ADDENDUM NO. 4

PROJECT NO. DGS C-0114-0006 PHASE 001
PROJECT TITLE - Hickory Run State Park - Latrine Improvements
PROFESSIONAL:

Response to Bidder Questions

DRAWING NO.:
ASK-1

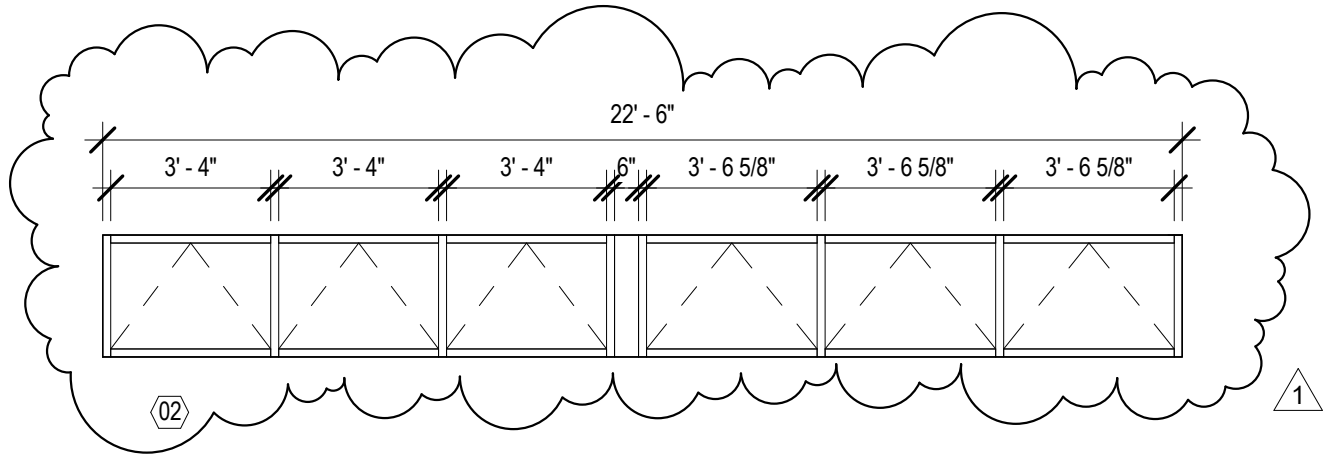
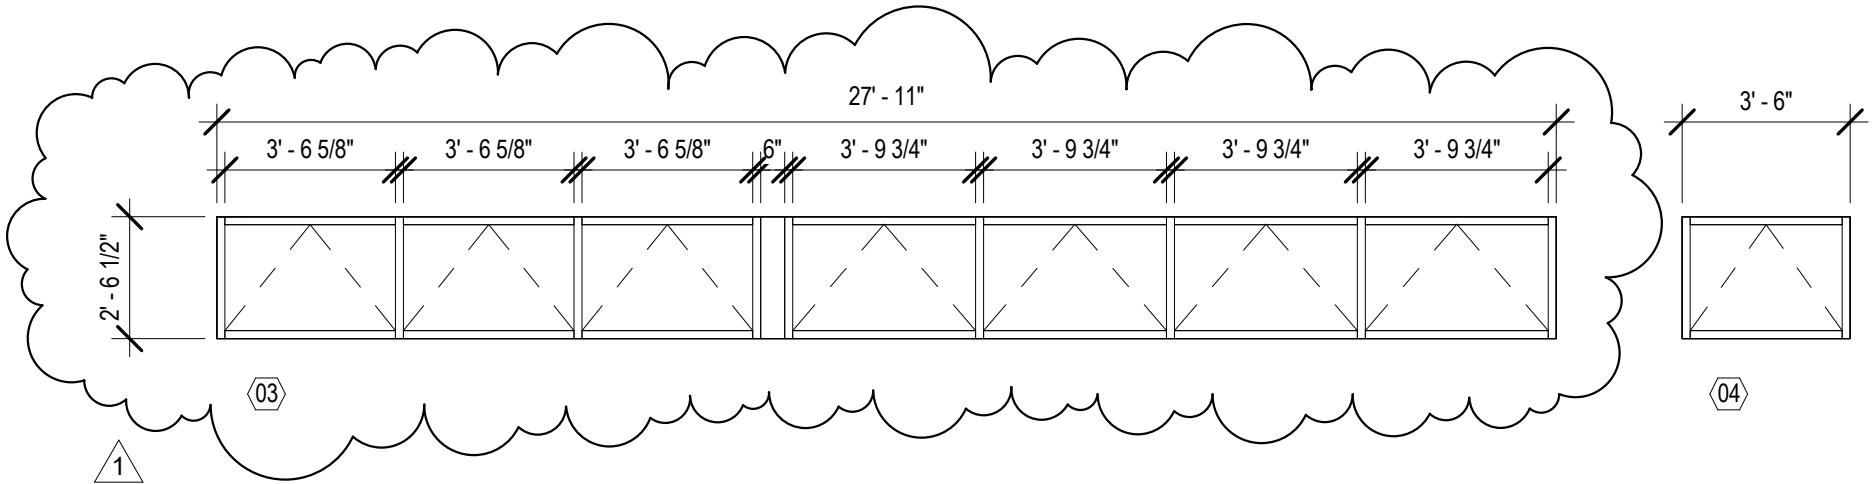
3. The Max allowed width of the exterior hopper style windows is 60" as per the manufacturer.. On drawing A-24 the windows widths exceed this. Please advise if we should add an additional window in the same sized opening to allow the individual windows to be under 60" each.

Response: Refer to attached sketch ASK-1 for two revised window types.

TITLE:
REVISED WINDOW TYPES 2 & 3
